Access Compliance Report

Public Rights-of-Way

Intersection ID: 43687	Main Street: PORTSTEWART_LN	Cross Street: TODDINGTON_LN	Location: SW
ADA ID: E89B61114362	Ramp Type: BlendTrans1	Initial Pass/Fail: Fail	Overall Compliance: No
		Severity Score: 8.75

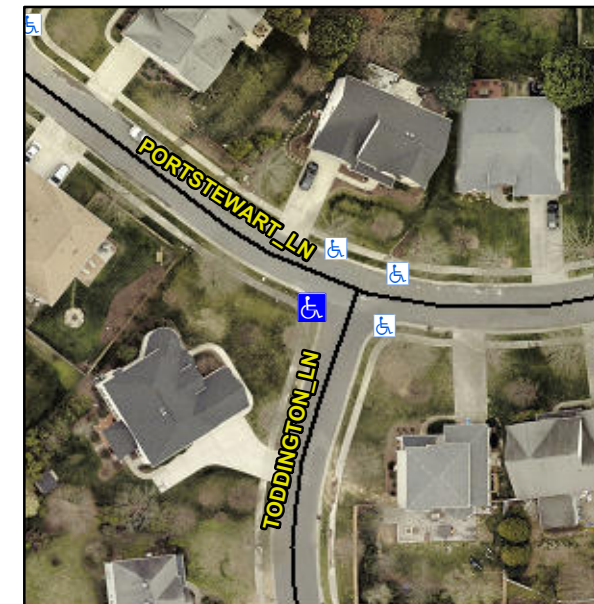
Not Found, R304.5.1

Compliance	Description	Data	Compliance	Description	Data
N/A	Ramp Length (in)	50.0	Yes	BlendTrans Slope (%)	3.2
No	Ramp Width (in)	45.0	Yes	BlendTrans XSlope (%)	0.8
N/A	Flare Type LT	N/A	N/A	Flare Type RT	N/A
N/A	Flare Slope LT (%)	N/A	N/A	Flare Slope RT (%)	N/A
N/A	Flare Traversable LT?	N/A	N/A	Flare Traversable RT?	N/A
N/A	Landing Length (in)	N/A	N/A	DWS Provided?	N/A
N/A	Landing Width (in)	N/A	N/A	DWS Contrast?	N/A
N/A	Landing Slope (%)	N/A	N/A	DWS Length (in)	N/A
N/A	Landing X Slope (%)	N/A	N/A	DWS Full Width?	N/A
N/A	Landing Curb? (Y/N)	N/A	N/A	DWS Offset (in)	N/A
N/A	Shared Landing?	N/A			
N/A	Gutter Ponding?	N/A	N/A	Gutter Slope (%)	N/A
N/A	Gutter Lip Ht (in)	N/A	N/A	Gutter X Slope (%)	N/A
N/A	Painted X Walk1?	No	N/A	Painted X Walk2?	No
	X Walk 1 Direction	To E		X Walk 2 Direction	To N
	X Walk 1 Width (in)	N/A		X Walk 2 Width (in)	N/A
	X Walk 1 Slope (%)	4.2		X Walk 2 Slope (%)	4.3
	X Walk 1 X Slope (%)	3.4		X Walk 2 X Slope (%)	2.5

N/A	Ramp inside XWalk1?	N/A	N/A	Ramp inside XWalk2?	N/A
	Road Slope (%)	2.0		Clear Space?	N/A
	Road X Slope (%)	7.0	N/A	Clear Space to XWalk (in)	N/A
N/A	Any Obstructions?	N/A	N/A	Storm Grate/Utility Hazard?	N/A
	Obstruction Type			Storm Grate/Utility Type	
		N/A			N/A
			Yes	Surface Condition? (G/P)	Good
			No	Curb Slope (%)	11.8

Remove & Replace Curb Ramp With Two New Directional Ramps or Equivalent.
